Project	IEEE 802.16 Broadband Wireless Access Working Group < http://ieee802.org/16 >	
Title	Initial rangin clarifications for OFDMA PHY	
Date Submitted	2004-04-22	
Source(s)	Itzik Kitroser Yossi Segal Yigal Leiba Zion Hadad Runcom Technologies Ltd. 2 Hachoma St. 75655 Rishon Lezion, Israel	Voice: +972-3-9528440 Fax: +972-3-9528805 mailto:itzikk@runcom.co.il mailto:yossis@runcom.co.il mailto:yigall@runcom.co.il mailto:zionh@runcom.co.il
Re:	802.16-REVd Sponsor ballot recirc	
Abstract	Text modifications to provide clarifications for OFDMA PHY initial ranging	
Purpose	Adopt suggested changes into P802.16-REVd/D4 draft	
Notice	This document has been prepared to assist IEEE 802.16. It is offered as a basis for discussion and is not binding on the contributing individual(s) or organization(s). The material in this document is subject to change in form and content after further study. The contributor(s) reserve(s) the right to add, amend or withdraw material contained herein.

Initial Ranging clarifications for OFDMA PHY

The motivation of the proposed changes is to add editorial clarifications for the OFDMA initial ranging process, which is currently ambiguously described in the standar

Table 101—CDMA Ranging and automatic adjustments procedure

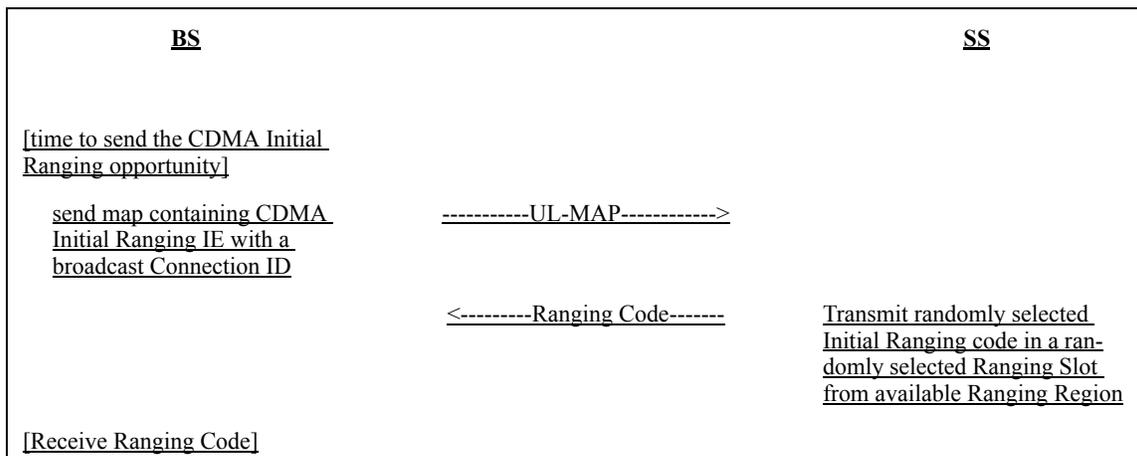
[Insert new table 101]

<u>BS</u>		<u>SS</u>
<u>Send RNG-RSP with Time & Power Corrections and original Ranging Code and Ranging Slot</u>		
<u>Status = Continue</u>	-----RNG-RSP----->	
		<u>Receive RNG-RSP message with Ranging Code and Ranging Slot matching sent values</u> <u>Adjust Time & Power parameters</u>
<u>[time to send the CDMA Initial Ranging opportunity]</u>		
<u>send map containing CDMA Initial Ranging IE with a broadcast Connection ID</u>	-----UL-MAP----->	
	<-----Ranging Code-----	<u>Transmit randomly selected Periodic Ranging code in a randomly selected Ranging Slot from available Ranging Region</u>
<u>[Receive Ranging Code]</u>		
<u>Send RNG-RSP with Time & Power Corrections and original Ranging Code and Ranging Slot</u>		
<u>Status = Success</u>	-----RNG-RSP----->	
		<u>Receive RNG-RSP message with Ranging Code and Ranging Slot matching sent values</u> <u>Adjust Time & Power parameters</u>
<u>[time to send the next map]</u>

<u>send map containing anonymous BW allocation with original Ranging Code and Ranging Slot</u>	-----UL-MAP----->	
	<-----RNG-REQ-----	<u>Transmit RNG-REQ and continue with regular Initial network entry</u>

Figure 83—CDMA Initial Ranging—SS (part 1)

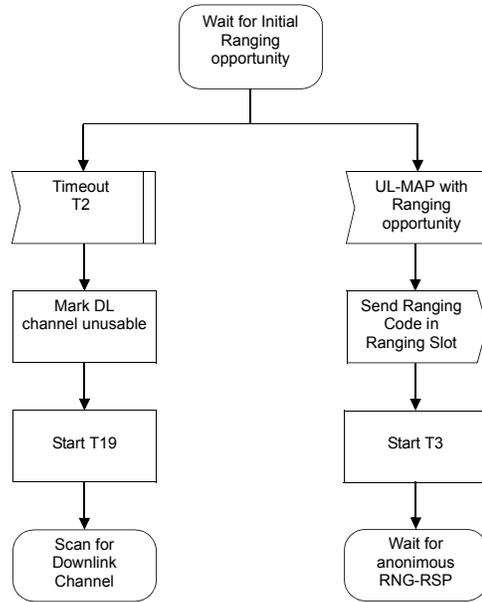
[Insert new figures 83-85]

Figure 86—Periodic ranging—Received ranging code—BS

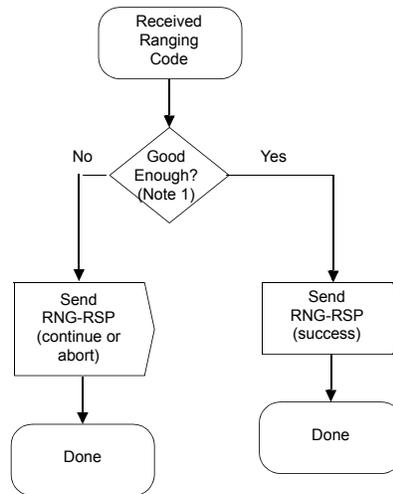
[Modify existing figure 84, on page 188, line 38 as follows]
